## **Comments Related to Latest Changes to Planning Application 2022/3796**

In addition to our individual objections to the original planning application 2022/3796, we now wish, jointly, to comment on:

Table 1:Habitat Areas AA Environmental

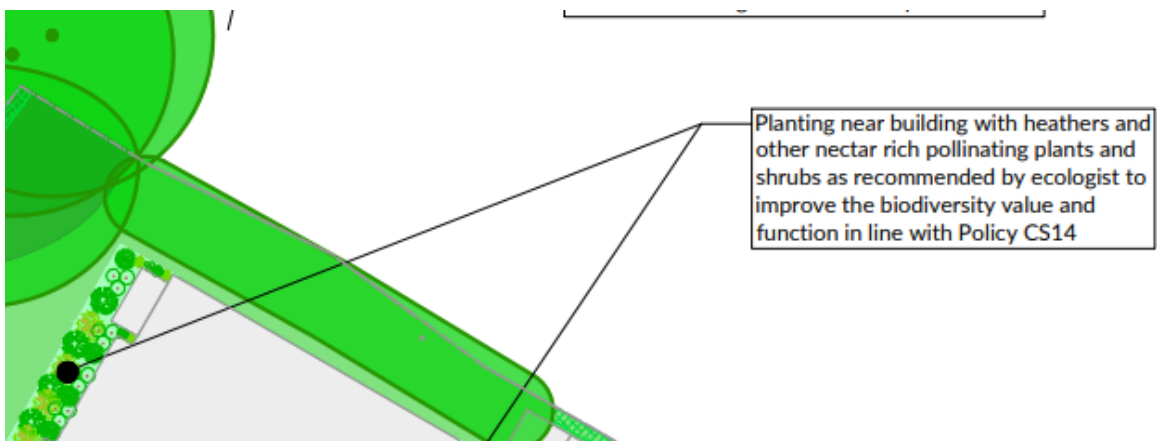
With specific reference to hedgerows, the Habitat Areas Table (Appendices 1) indicates a percentage increase in hedgerows of **54.42%**, despite the proposed removal of 3 existing, well established, dense hedgerows, namely:

Proposed new hedging is recorded as 0.112 km. From the drawings provided in the 14<sup>th</sup> June Report, there are approximately 12 small hedges, which look to be ornamental. If so and given their siting mostly around areas that will be heavily trafficked either by pedestrians or vehicles, they would support only limited wildlife and certainly none of the birds, small mammals or reptiles that use some of the existing hedgerow for food, shelter and nesting. We question how there is an increase of 54.42% (is this the overall volume of the hedgerows, or merely the length?). The Revision A report highlighted an increase of 137.89%, not including any existing hedgerows- a figure that does not appear remotely credible to us.

It should be highlighted that the amended plans, are completely at odds with the Landscape Plans provided by the developer. Where potential hedgerows are mooted, there are areas of planting (shrubs) which are not hedgerows (see Appendices 2).
